## Technical Note TN-923-SR

### Tait Orca 5030, 5035, 5040 Firmware Upgrade to 4.27 & TOP-TPA Upgrade to 4.0.1

15 October 2004

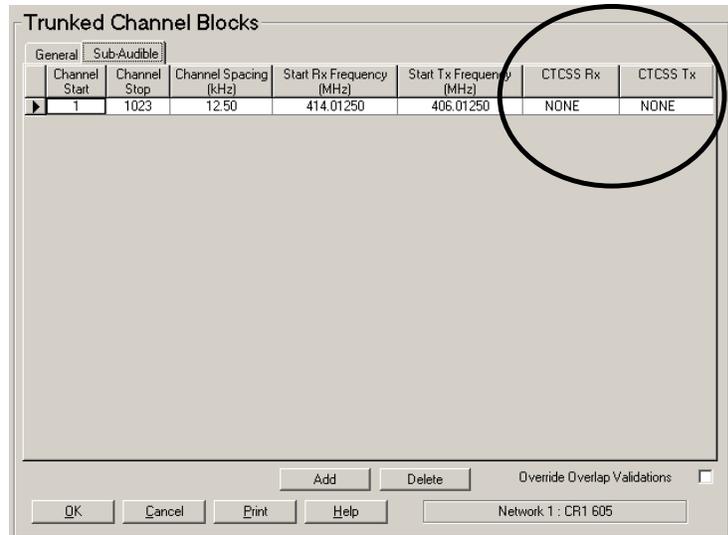
- A transmit and receive CTCSS frequency can now be defined for each trunked channel block. The CTCSS Rx field sets the sub-audible signalling that the radio must receive on the traffic channel before the activity is regarded as valid and the mute is opened. The CTCSS Tx field sets the sub-audible signalling that accompanies each transmission made on the traffic channel. (Raised as TIMS 29443).

**Note: The sub-audible frequency will only be used on the traffic channel.**
